FINAL DETERMINATION

Construction Permit

Longview Power LLC

Permit Application Number: R13-3495

Figure One from Commenter #6. Longview Rolling Annual Average Emission Rates²⁵

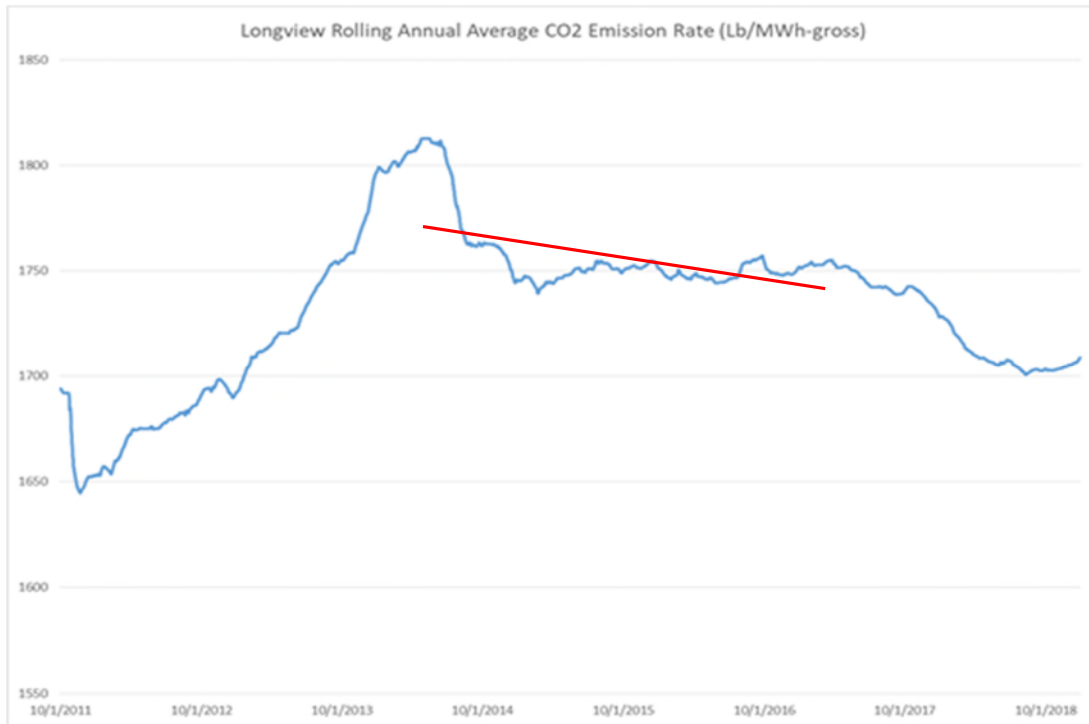
These data (See Figure One, below) also show that, after initial startup issues were resolved, the emission rate improved over time (as some – but by no means all - of the recommended HRI technologies were adopted) rather than degrading. It should also be understood that these rates include operation in all Load Bins and were achieved at a time when Longview's operator was under no obligation to maintain a specific emission limitation and may have found it to be economically rewarding to operate in a fuel-inefficient manner. Thus,

instead of seeking improvements in performance and reductions in emissions, the proposed limits in the draft permit would allow significant increases in greenhouse gas emissions.

DAQ's Response to Comment #10

Figure 1: Chart of the Heat Rate of LB-5 for LVP

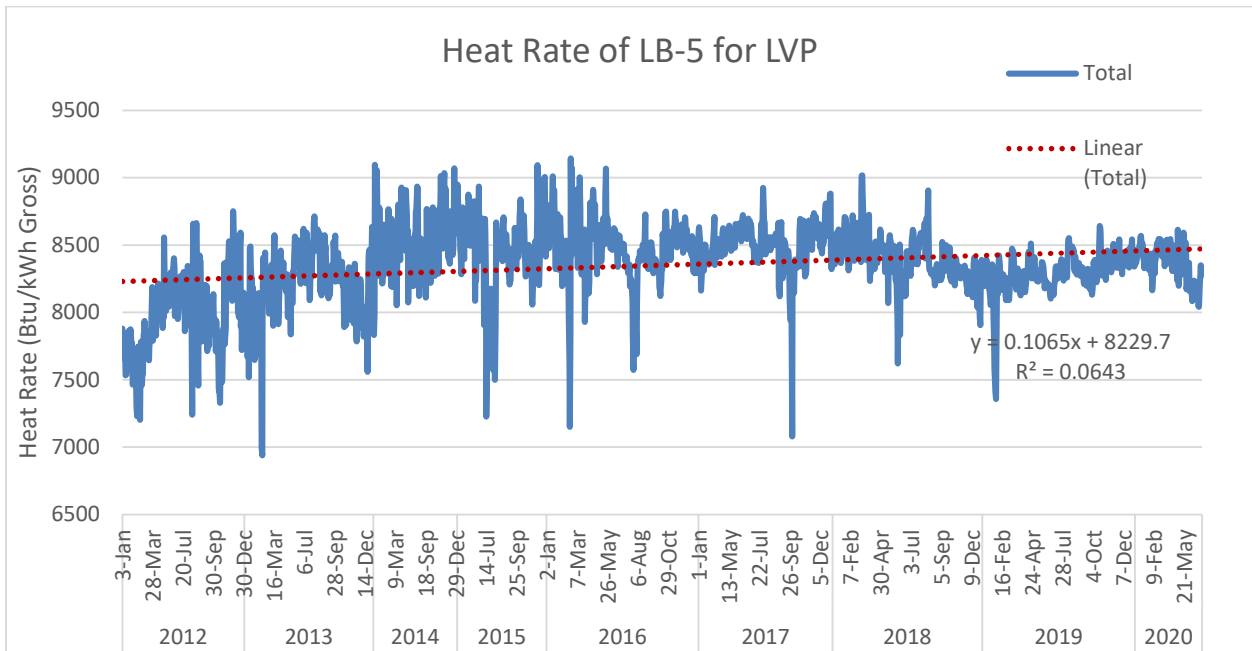
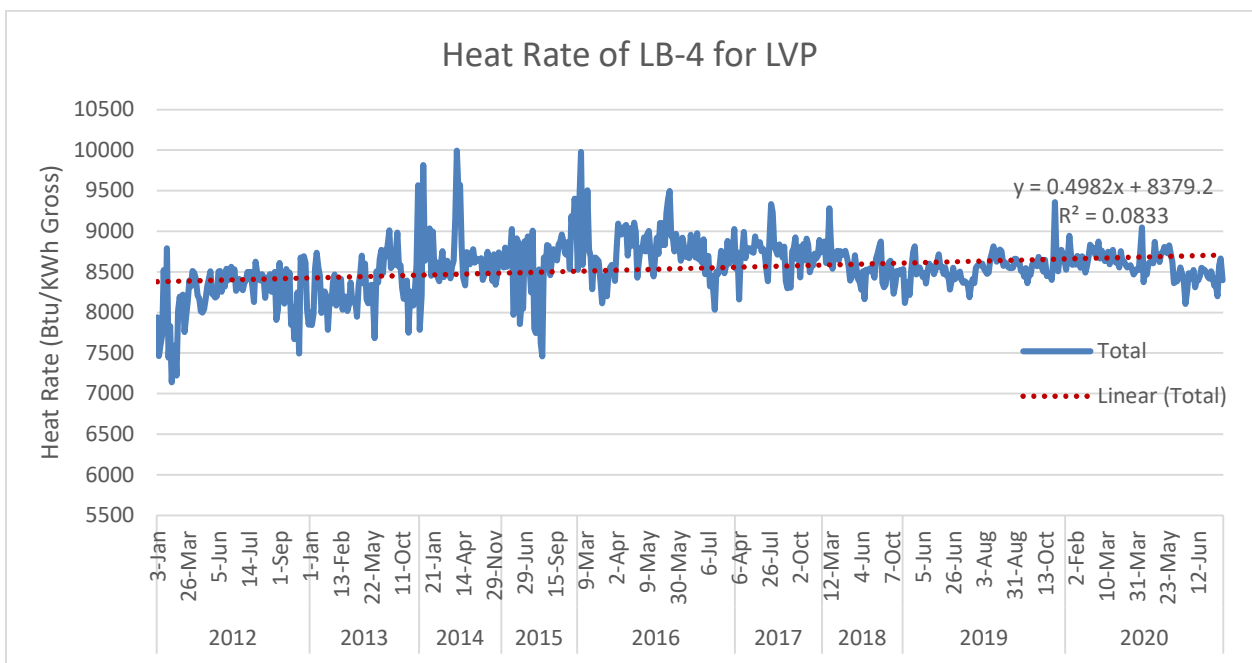
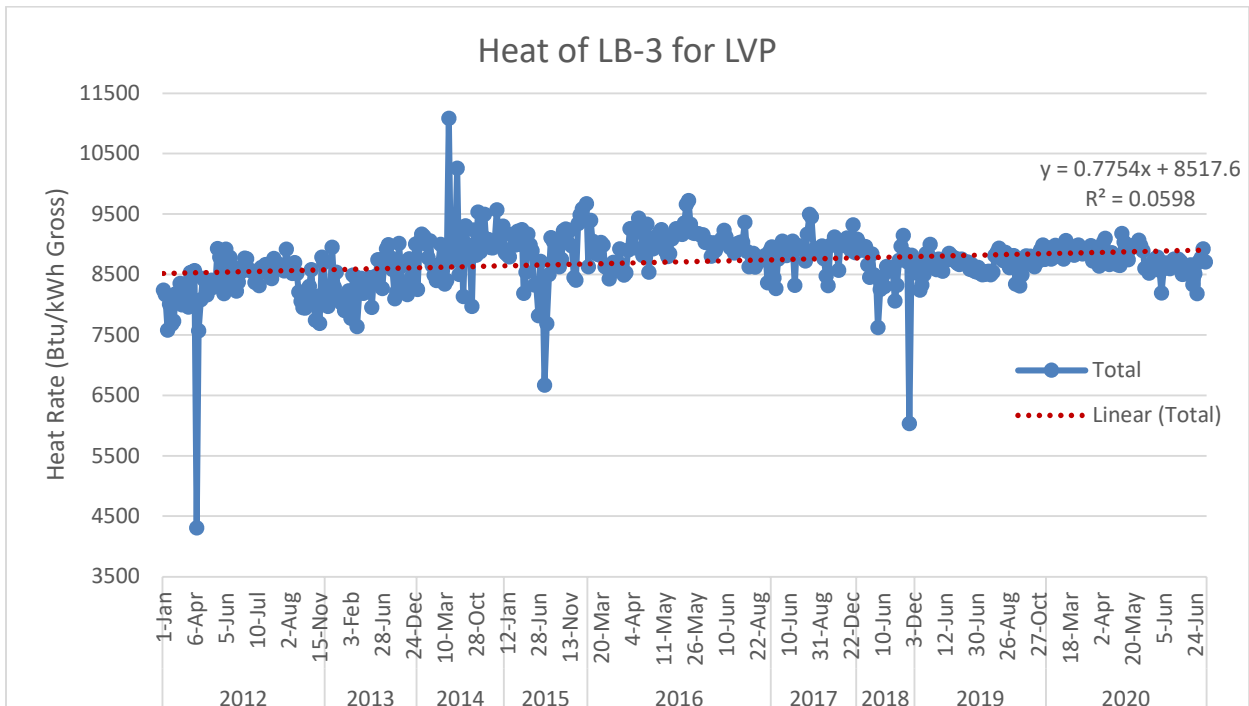
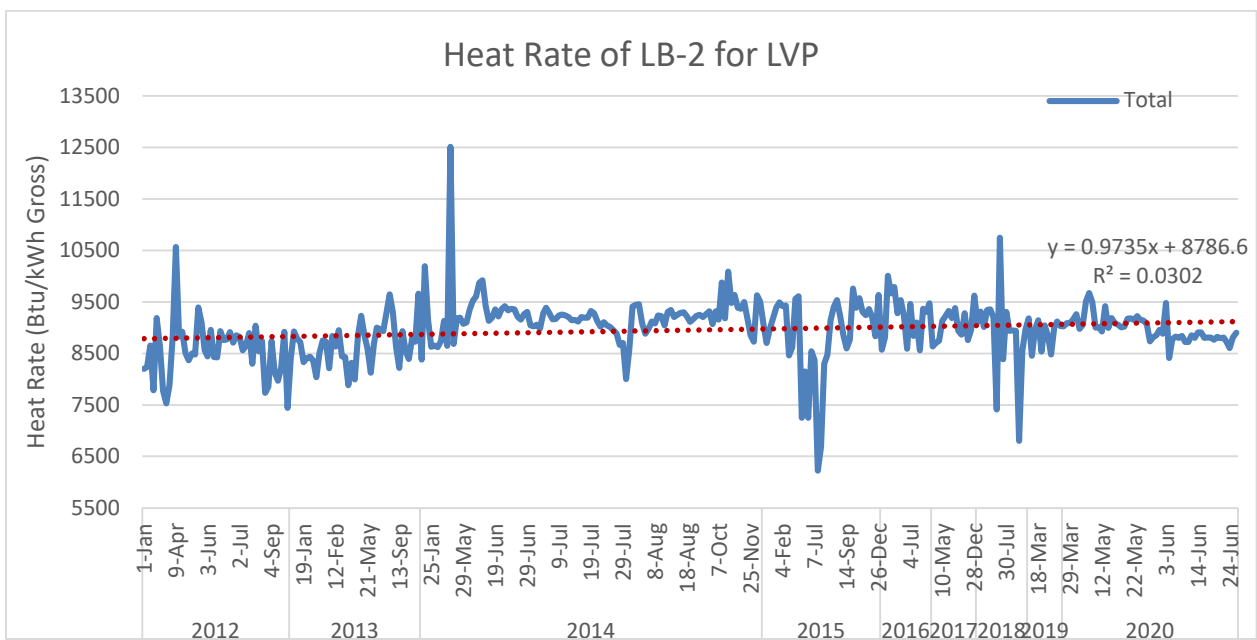
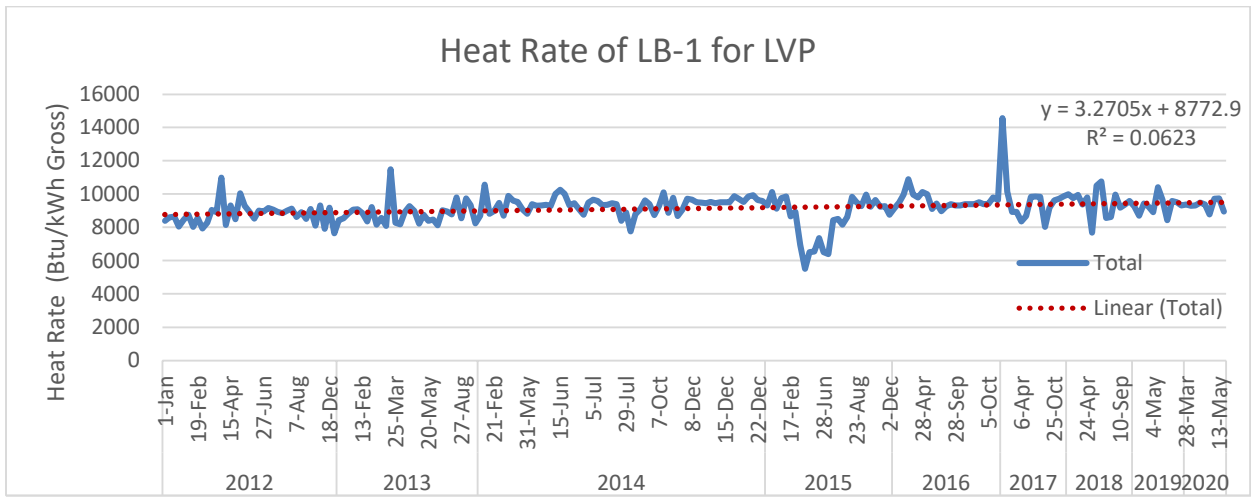
Section 4.1.1.c. The Unit Degradation Adjustment Factor (UDAF) allows a 0.4 % increase per year, with a 0.7% recovery every five years. These values appear to be based on Longview's analysis of historic data for similar plants within the region. Since none of these units are under any obligation to maintain a maximum emission rate, this data only tells us what has been done in the absence of a rule that is intended to change past practices. There does not appear to be any analysis of the extent to which new HRI technology or Operating and Maintenance Practices (O&M) programs were used in this fleet-wide analysis, yet the ACE rule clearly requires such on-going O&M to demonstrate Heat Rate Improvement compliance. Including emissions rates and UDAFs for plants that do not implement the needed O&M is inappropriate. The assumption that Unit Degradation is inevitable has not been demonstrated, and is directly contradicted the Longview performance data over the last 10 years and by the new legal obligation to achieve and maintain a specified heat rate or adopt Heat Rate Improvements.

The DAQ calculated the unit's heat rate on a gross basis from 2012 through 2nd Quarter 2020 by load bin. The following is the daily heat rate for Load Bin 5 with a linear trendline added to the chart.

The trendline indicates that the unit is degrading at a rate of 0.11 Btu/kWh for each operating day, which equates to an increase of 40 Btu/kWh on an annual basis. The other load bins are decaying at a higher rate than Load Bin 5, which are presented in the following charts (see the increase of the slope of the predicted linear function for each bin).

The proposed rate of 0.4% annually equates to approximately 35 Btu/kWh on an annual basis. These charts suggest that Longview Power will be required to find additional improvements to maintain compliance in the future or reduce the degradation rate by improving maintenance of equipment that affects the unit heat rate.

Figure 6: Actual Heat Rate Curve of LB-5 vs. Proposed Heat Rate Curve

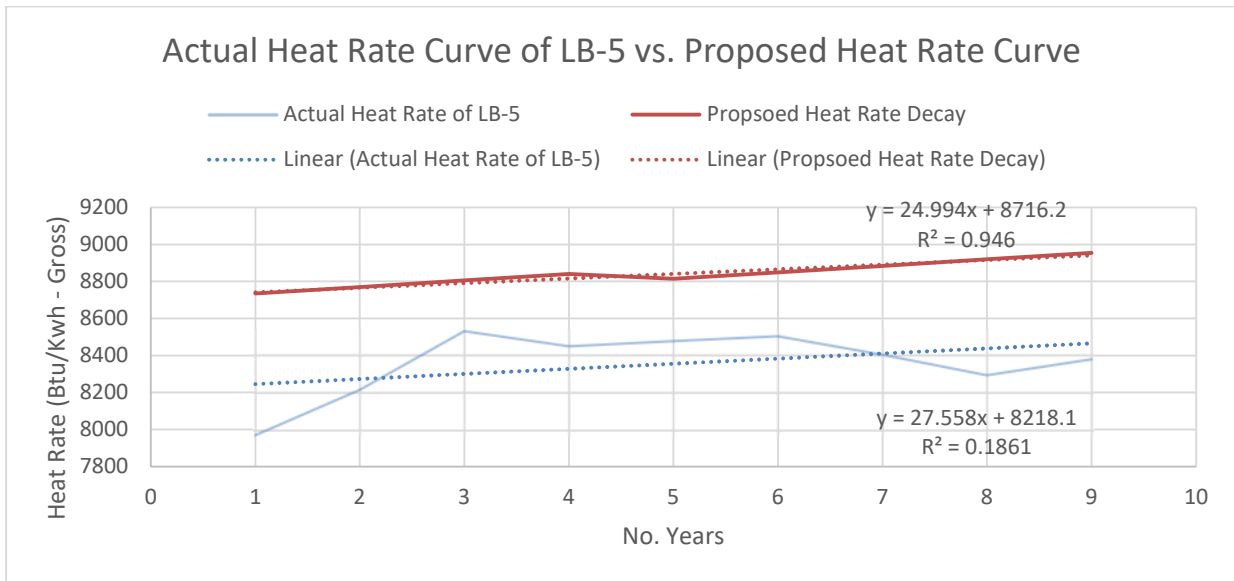
The UDAF also allows the emissions rate increases to compound year-over-year, thus allowing much larger annual increases in later years. There does not appear to be any evidence to justify this, and Figure 20 shows a linear, not logarithmic, increase (even in plants not required to implement Heat Rate Improvements). Since the goal is to limit greenhouse gas emissions, we recommend that the permit use lower rates for UDAF, provide better justification for any non-zero UDAF, and apply them only to the base year, rather than using a compound interest approach as currently proposed.

The DAQ's Response to Comment #14 indicates that the rate of decay (slope) of the actual unit's heat rate is increasing faster than the proposed degradation rate set forth in the permit. (See Figure 6.) From Figure 6, the DAQ understands that Longview Power will have to improve the unit's actual recovery rate order to maintain compliance in the future (e.g., reduce the amount of heat rate that is lost due to equipment degradation) or implement additional HRI to offset the unit's degradation rate.

Figure 9: Chart of the Heat Rate of LB-5 for the John Turk Unit

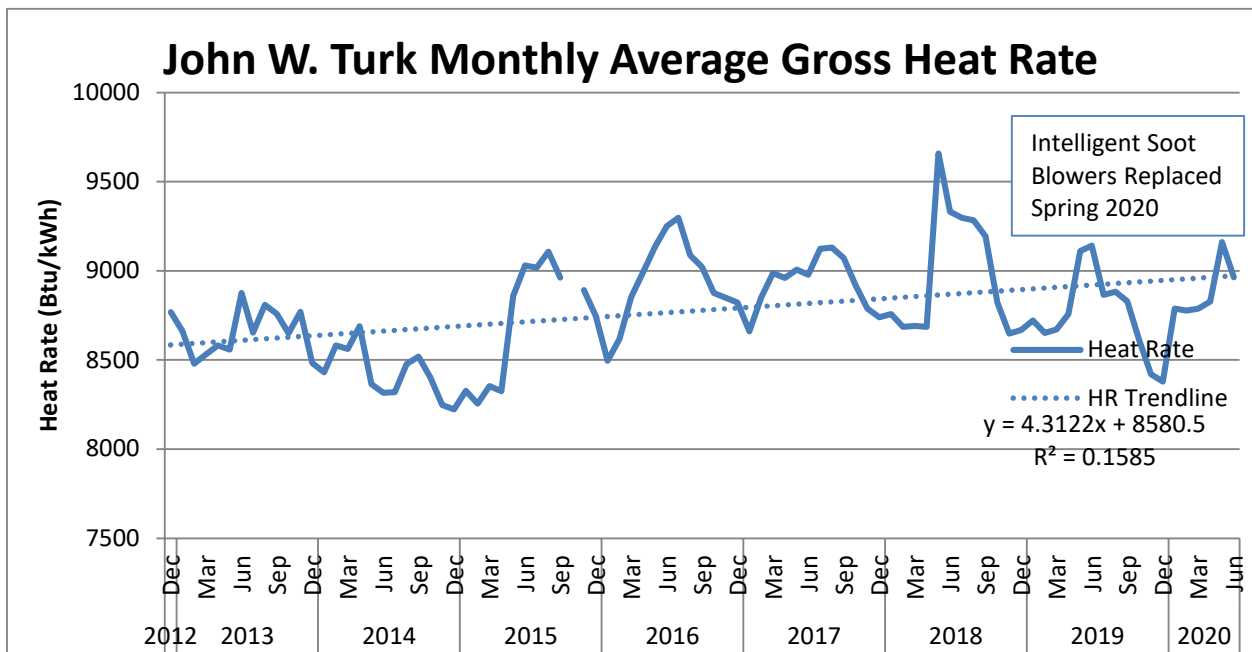
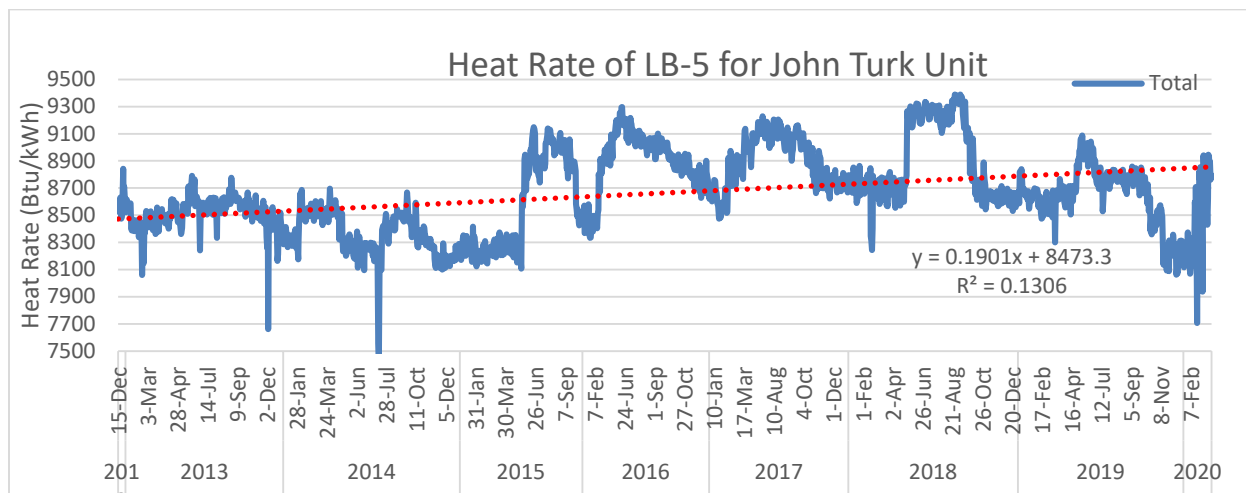
6. Longview assumes that the efficiency of their facility declines with age and that might seem intuitively obvious, but does DEP have any data from a modern coal-fired power plant such as Longview, one that is well maintained, to show that this is inevitable? Is there any reason to think that with proper maintenance the emissions level has to continuously increase?

The DAQ was reluctant to consider other plant data (heat rate) as a benchmark in developing the standard or in specifically justifying Longview Power’s degradation rate. In comparison of best heat rate with Longview Power’s unit, AEP’s John W. Turk Plant in Arkansas is one of the best performing units. Both units are comparable in age with less than a one-year difference. The Turk unit was designed to operate as an ultra-super critical unit, which is more efficient than a super critical unit.

The DAQ enhanced the resolution of the chart by calculating the heat rate of LB-5 using the reported hourly operating data and averaging the heat rate daily. The added trendline estimated the degradation rate for this bin to be 69 Btu/kWh on an annualized basis.
